Access Compliance Report

Public Rights-of-Way

(Curb Ramps)

Intersection ID: 9172	Main Street: E_CRAIGHEAD_RD	Cross Street: N_TRYON_ST	Location:	S
ADA ID: 76FEAD854FCC	Ramp Type: Perp	Initial Pass/Fail: Fail	Overall Compliance: No	Severity Score: 22.5
Codes/Mitigation Info/Possible Solution		Field Measurements/Component Compliance

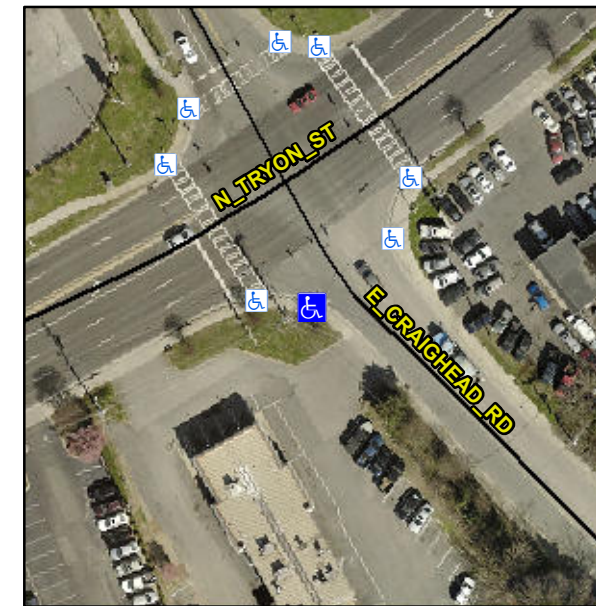
Not Found, R304.5.1, R304.2.2, R304.5.3

Compliance	Description	Data	Compliance	Description	Data
N/A	Ramp Length (in)	71.5	No	Ramp Slope (%)	9.3
No	Ramp Width (in)	44.0	No	Ramp XSlope (%)	3.1
N/A	Flare Type LT	N/A	N/A	Flare Type RT	N/A
N/A	Flare Slope LT (%)	N/A	N/A	Flare Slope RT (%)	N/A
N/A	Flare Traversable LT?	N/A	N/A	Flare Traversable RT?	N/A
N/A	Landing Length (in)	N/A	N/A	DWS Provided?	N/A
N/A	Landing Width (in)	N/A	N/A	DWS Contrast?	N/A
N/A	Landing Slope (%)	N/A	N/A	DWS Length (in)	N/A
N/A	Landing X Slope (%)	N/A	N/A	DWS Full Width?	N/A
N/A	Landing Curb? (Y/N)	N/A	N/A	DWS Offset (in)	N/A
N/A	Shared Landing?	N/A			
N/A	Gutter Ponding?	N/A	N/A	Gutter Slope (%)	N/A
N/A	Gutter Lip Ht (in)	N/A	N/A	Gutter X Slope (%)	N/A
N/A	Painted X Walk1?	Yes	N/A	Painted X Walk2?	N/A
	X Walk 1 Direction	To NE		X Walk 2 Direction	N/A
N/A	X Walk 1 Width (in)	81.5	N/A	X Walk 2 Width (in)	N/A
	X Walk 1 Slope (%)	0.2		X Walk 2 Slope (%)	N/A
	X Walk 1 X Slope (%)	2.7		X Walk 2 X Slope (%)	N/A

Remove & Replace Entire Ramp.
